Access Compliance Report

Public Rights-of-Way

(Curb Ramps)

Intersection ID: 10040781	Main Street: W_TYVOLA_RD	Cross Street: N/A	Location: SE
ADA ID: 34BA9D5CBE1B	Ramp Type: ParaDiag	Initial Pass/Fail: Fail	Overall Compliance: No
Severity Score: 12.5			
Codes/Mitigation Info/Possible Solution		Field Measurements/Component Compliance

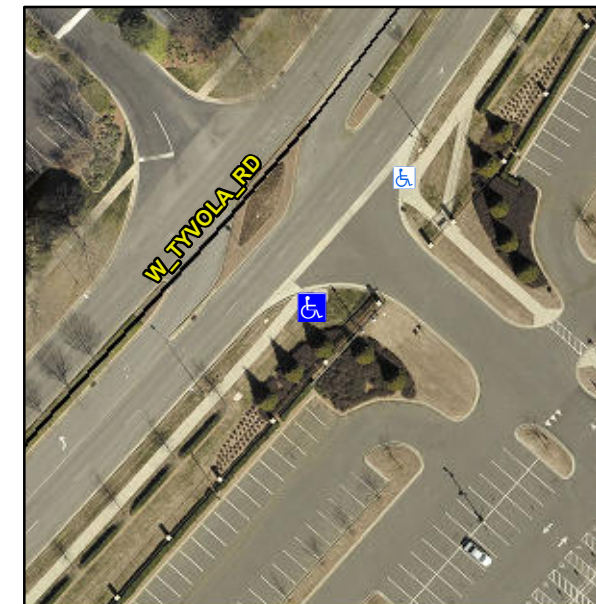
R304.3.2

Compliance	Description	Data	Compliance	Description	Data
N/A	Ramp Length LT (in)	84.0	N/A	Ramp Length RT (in)	59.0
Yes	Ramp Width LT (in)	77.5	Yes	Ramp Width RT (in)	80.0
No	Ramp Slope LT (%)	9.0	Yes	Ramp Slope RT (%)	5.7
Yes	Ramp XSlope LT (%)	1.4	Yes	Ramp XSlope RT (%)	0.2
N/A	Landing Length (in)	N/A	N/A	DWS Provided?	N/A
N/A	Landing Width (in)	N/A	N/A	DWS Contrast?	N/A
N/A	Landing Slope (%)	N/A	N/A	DWS Length (in)	N/A
N/A	Landing X Slope (%)	N/A	N/A	DWS Full Width?	N/A
N/A	Landing Curb? (Y/N)	N/A	N/A	DWS Offset (in)	N/A
N/A	Shared Landing?	N/A			
N/A	Gutter Ponding?	N/A	N/A	Gutter Slope (%)	N/A
N/A	Gutter Lip Ht (in)	N/A	N/A	Gutter X Slope (%)	N/A
N/A	Painted X Walk1?	No	N/A	Painted X Walk2?	No
	X Walk 1 Direction	To NE		X Walk 2 Direction	To NW
N/A	X Walk 1 Width (in)	N/A	N/A	X Walk 2 Width (in)	N/A
	X Walk 1 Slope (%)	1.4		X Walk 2 Slope (%)	4.9
	X Walk 1 X Slope (%)	1.7		X Walk 2 X Slope (%)	3.4
N/A	Ramp inside XWalk1?	N/A	N/A	Ramp inside XWalk2?	N/A

Remove & Replace Curb Ramp With Two New Directional Ramps or Equivalent.
